ACCESS REPORT

DEVELOPMENT APPLICATION

25-27 GEORGE STREET, THE ROCKS SYDNEY

1st December 2017

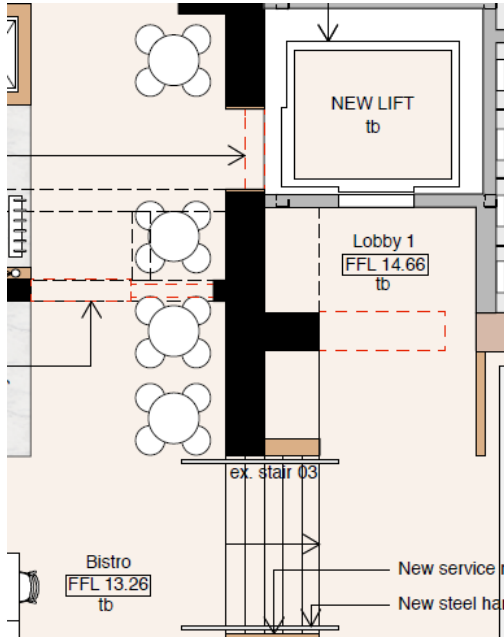
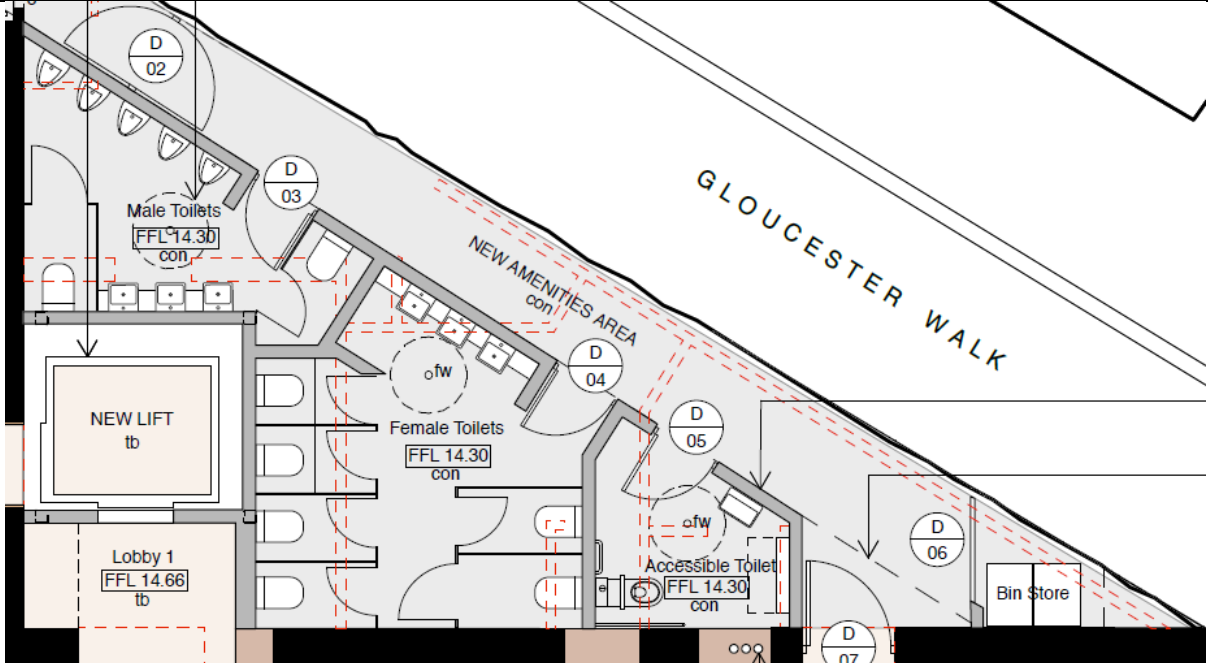
BCA / DDA Compliance	Complies
<p>1. To ensure appropriate pedestrian access from George Street that is wheelchair accessible the northern doors shall incorporate lever door handles and upgrade the external pavement at the northern doorway to provide an accessible entrance into the premises in accordance with AS1428.1 to satisfy Part D3.2 of the BCA 2016 and DDA Premises Standards.</p> <p>2. The new works will also install at least two signs at the inaccessible stairway entrances and a third sign at the northern doorway advising of the accessible northern doorway consistent with D3.6 of the BCA and DDA Premises Standards.</p>	<p>YES</p> <p>YES</p>

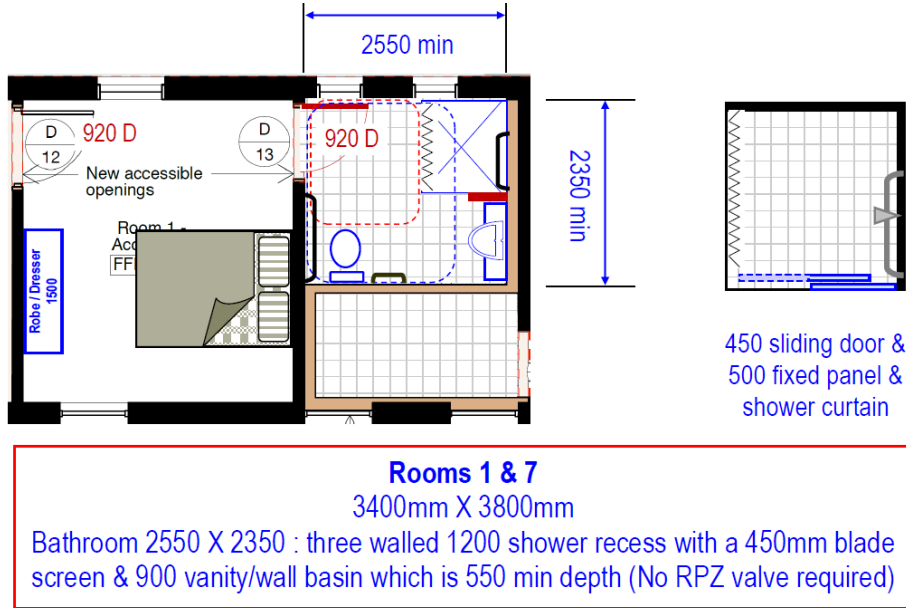
BCA / DDA Access Code Review		Complies
GROUND FLOOR		
4. Internal Access: Ground Floor - Within the ground floor area of the hotel the plans show a split floor level with a lift and stairway providing access between the levels of the lounge bar / bistro / dining areas and sanitary facilities to ensure equitable access to satisfy Part D3.3 of the BCA, DDA Premises Standards.		YES

5. The new lift proposes a dual doorway to enable access to split floor levels. The lift landings provide adequate area for turning and passing consistent with AS1428.1 and E3.5 of the BCA and DDA Premises Standards.		YES

6. The plans indicate a 1600 X 1400mm lift car which facilitates adequate space to facilitate a turn to enter and turn exit the lift in a forward direction for added convenience.		YES

7. The bistro and courtyard stairways will also include 50-75mm width colour contrasting step nosings, tactile ground surface indicators and other features in accordance with AS1428.1 / AS1428.4.1 to satisfy Parts D3.3 and D3.8 of the BCA and DDA Premises Standards.		YES at CC stage

8. Bistro & Courtyard - The circulation spaces within the ground floor bistro provide appropriate access for Turning, Passing and to the courtyard doorways which include a 920mm door and level thresholds to ensure equitable access to satisfy Part D3.3 of the BCA and DDA Premises Standards.		YES

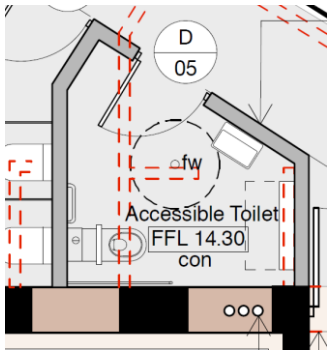
Ground Floor Dual Access	First Floor Dual Access	Second Floor Dual Access	Roof Terrace	
FIRST FLOOR				
<p>15. Internal Access: – Access from the lift to the reception desk and the Accessible Suite No. 1 provides adequate access for Turning and Passing Areas to comply with AS1428.1 and satisfy Part D3.3 of the BCA and DDA Premises Standards.</p> <p>16. The remainder of the first floor structure and layout of rooms is existing and no new works are proposed due to the heritage significance of the premises, with exception of;</p> <ul style="list-style-type: none">a) Demolition of two partition walls and four (4) doorway openings.b) Installation of bathroom pods for the 6 accommodation suites, coolroom and other fitout items of the commercial kitchen which are generally free-standing of the structural walls.				<p>YES</p> <p>N/a</p>

<p>17. Notwithstanding the minimal intervention on the first floor, retention of the central corridor and limited access for people who use a wheelchair beyond the reception it is my opinion that the overall provision of the new lift and Accessible suite No. 1 readily complies with Part D3.3 and DPI of the BCA and DDA Premises Standards.</p>				<p>YES</p>

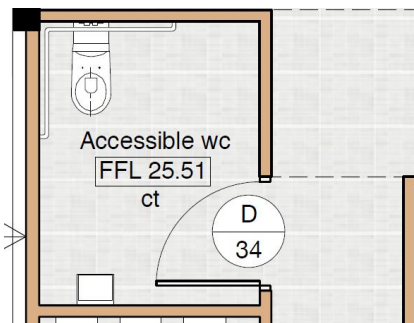
BCA / DDA Access Code Review	Complies
<p>SECOND FLOOR</p> <p>18. Internal Access: – Access from the lift to the reception desk and the Accessible Suite No. 7 provides adequate access for Turning and Passing Areas to comply with ASI428.1 and satisfy Part D3.3 of the BCA and DDA Premises Standards.</p> <p>19. The dual access from the new lift will enable access to the staff room and a small office, albeit the circulation spaces are marginally less than current requirements of ASI428.1 for the larger A90 wheelchair user. Nonetheless the proposed corridor and doorways enable access for the majority of wheelchair users to reasonably satisfy the performance requirement DPI of the BCA and DDA Premises Standards.</p> <p>20. The remainder of the second floor structure and layout of rooms is existing and no new works are proposed due to the heritage significance of the premises, with exception of;</p> <ul style="list-style-type: none"> a) Demolition of three partition walls and four (4) doorway openings. b) Installation of bathroom pods for the 5 accommodation suites, caretakers residence which are generally free-standing of the structural walls. c) Extension of a fire exit stairway to the roof terrace level. <p>21. The extension of the fire exit stairway to the roof terrace shall ensure the new handrails and stairway nosings shall comply with Clauses 11.1(d)(e)(f)(g) and 12 of ASI428.1 to satisfy parts D2.17, D2.14, D3.3(a)(iii) of the BCA.</p>	<p>YES</p> <p>YES Performance based compliance</p> <p>N/a</p> <p>YES at CC Stage</p>

<p>22. Notwithstanding the minimal intervention on the second floor, retention of the central corridor and limited access for people who use a wheelchair beyond the reception it is my opinion that the overall provision of the new lift and Accessible suite No. 7 readily complies with Part D3.3 and DPI of the BCA and DDA Premises Standards.</p>	<p>YES</p>

Merchantile Hotel, 27-29 George Street, Sydney

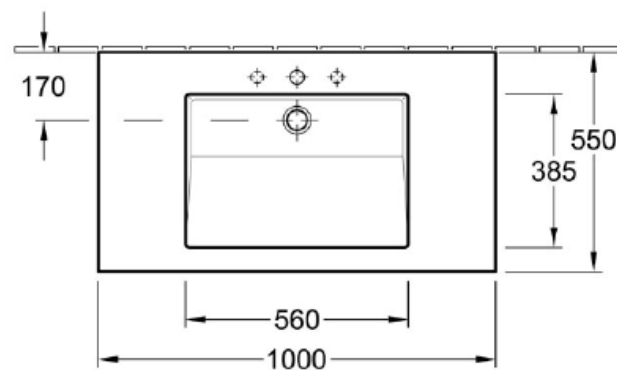
Rooms 1 & 7
3400mm X 3800mm
Bathroom 2550 X 2350 : three walled 1200 shower recess with a 450mm blade screen & 900 vanity/wall basin which is 550 min depth (No RPZ valve required)
